CONSTRUCTION SUMMARY OF EXTRAS

Site: WASAGA

136-5

Purchaser:
Phone/Email: Model: SAND TH-06 (A)
KENNETH & PAULINA ROBERTSON
705-818-2326

THE SAND TH-06

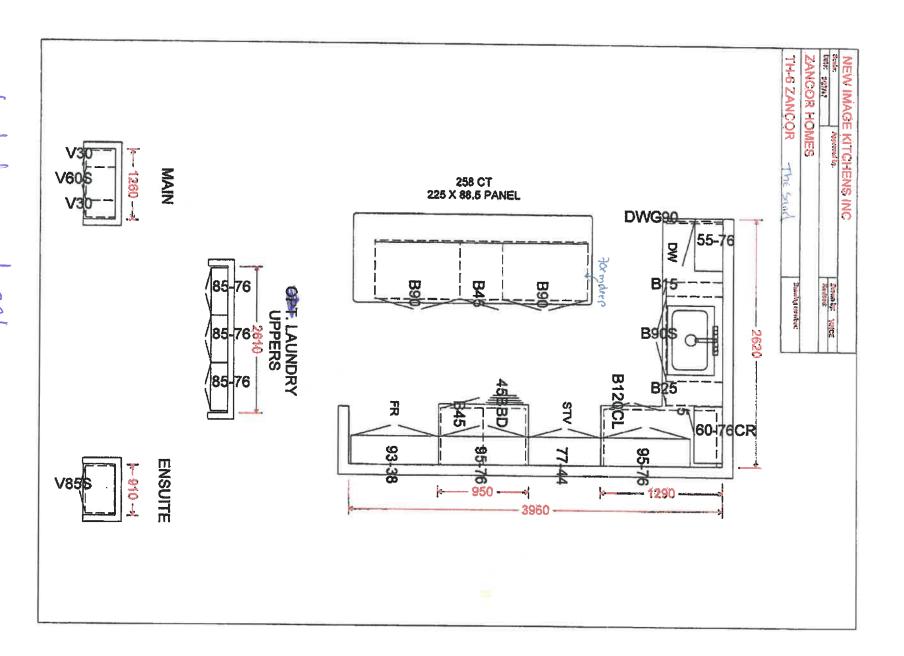
- Extended uppers to 59/2

- two tone Island.

- they have Island.

- Pot Brawes in Island

- Valance.
